Re: Application to Amend Order SWD-1684
Mesquite SWD, Inc.
Red Hills SWD Well No. 1
API No. 30-025-45028
1500' FNL & 430' FEL, Unit H
Section 5, T-26S, R-33E, NMPM,
Lea County, New Mexico

Mesquite SWD, Inc. ("Mesquite"), the operator of the Red Hills SWD No. 1, respectfully requests that Order SWD-1684 be amended to authorize the use of 7" tubing inside the 9 5/8" intermediate casing and 5 ½" tubing inside the 7 5/8" liner.

Mesquite SWD, Inc. Application to Amend SWD-1684 Red Hills SWD No. 1

Exhibit 3 **Proposed Wellbore Configuration Application to Amend SWD-1684** Pod Hills SWD Wall No. 1

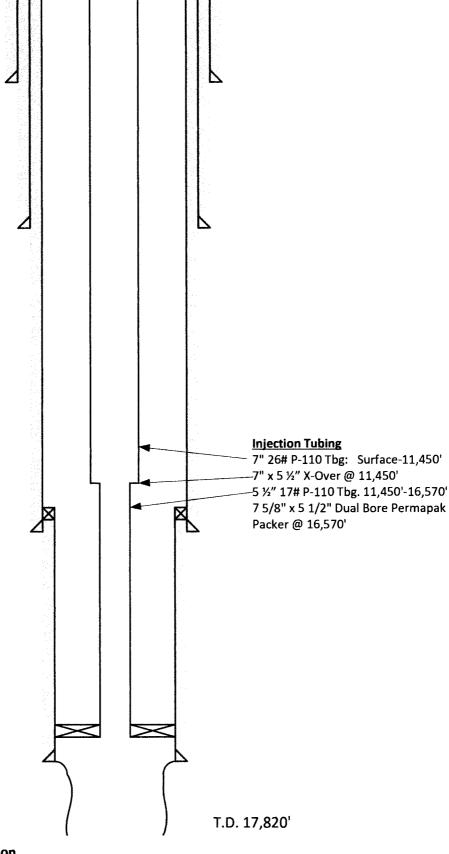
- 1. Copy of Order SWD-1684 (Exhibit 1);
- 2. Attached is the wellbore schematic originally submitted with the C-108 application received by the Division on May 1, 2017 (Exhibit 2). Also attached is a wellbore schematic that shows the proposed wellbore configuration (Exhibit 3). (Please note that the casing and cementing program for this well is not being amended);
- 3. OCD GIS map (Exhibit 4) showing the location of the Red Hills SWD No. 1 and the surrounding 9-section area. An examination of Division records indicates that there are currently no additional Devonian/Silurian produced water disposal wells within this 9-section area;
